Product Change Notice (PCN)

PCN Number: PCN-0456172R-01

Product(s) Affected: PJ-040CH

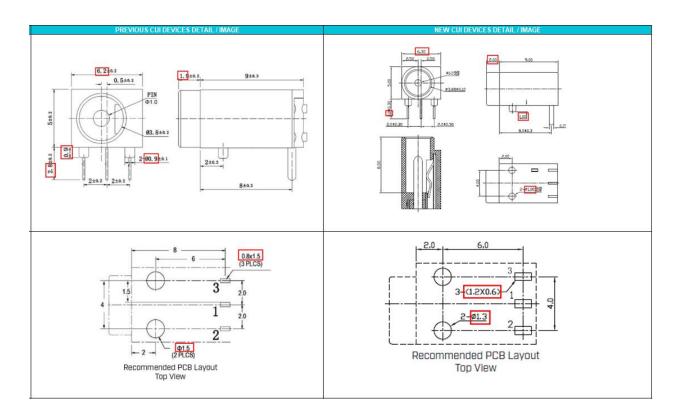
Description of Change: New Factory Location. Product re-engineered for improved manufacturability and production yield. See image below for reference and check CUI Devices website for updated drawing. Cosmetic differences may be visible and not affect the form fit and function of the product.

Р	REVIOUS CUI DEVICES DE	TAIL / IMAGE			NEW CUI DEVICES DETAIL	IMAGE
DESCRIPTION	MATERIAL	PLATING/COLOR		DESCRIPTION	MATERIAL	PLATING/COLOR
center pin	brass	silver	_	center pin	brass	silver
terminal 1	brass t=0.25	silver	_	terminal 1	brass t=0.25	silver
terminal 2	brass :=0.25	silver		terminal 2	SUS301 t=0.25	silver
terminal 3	brasst=0.25	silver				
cover	PBT (UL94V-0)	black		terminal 3	brass t=0.25	silver
housing	PBT (UL94V-0)	black		housing	PA66 UL94V-0)	black
Ø3.5 Ø1.1 MATING PLUP Jack Insertion Depth B.D mm				MATING PLUG		
Jack inserdon Deput 6.0 min				Jac	k Insertion Depth 8.5	1111
